From: [Redacted]
Sent: 11/10/2011 3:24:00 PM
To: Shori, Sunil (sunil.shori@cpuc.ca.gov) (sunil.shori@cpuc.ca.gov)
Cc: Medina, Joe A (/O=PG&E/OU=CORPORATE/CN=RECIPIENTS/CN=JAMN);
Singh, Sumeet
(/O=PG&E/OU=CORPORATE/CN=RECIPIENTS/CN=S1ST56905772); Horner,
Trina (/O=PG&E/OU=CORPORATE/CN=RECIPIENTS/CN=TNHC)
Bcc:
Subject: RE: RE: Pressure Restoration Filing - Data Request 3 - (Email 1 or 4)

Updated Table - Amendment to 10/31 filing

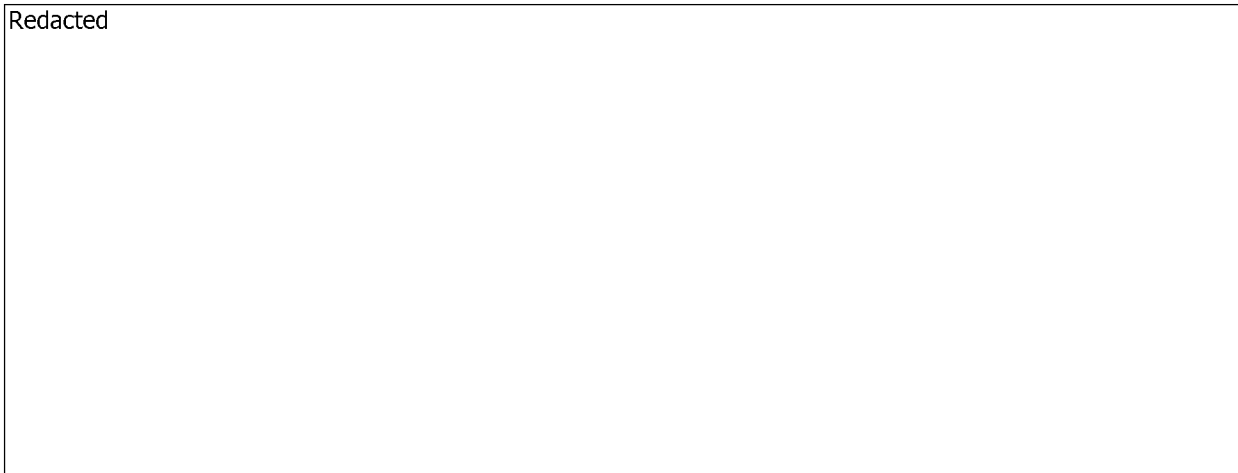
I don't have the data with me to be able to review the MAOP shown for M.P. 32.17 to 33.68; however, the corrected table is acceptable. As for the specific pages related to the questions, I can't provide those right now, but they are mostly related to the documentation for the excavations that PG&E provided.

Per our discussion, please review the table below and kindly let us know if the proposed update is consistent w/ the discussions that you had w/ Sumeet and Shilpa. We would like to file this amendment by tomorrow afternoon. For your reference, I have also included the original table that was presented in our 10/31 filing.

However, I believe this is incorrect for Line 101 and possibly Lines 132A and 147. In the case of Line 101, I believe PG&E had specified the MAOP to be 400 psig up to Lomita Park Station. PG&E needs to confirm the MAOPs for all three lines and provide necessary corrections in its next filing. If PG&E does not agree with my assessment, please let me know.
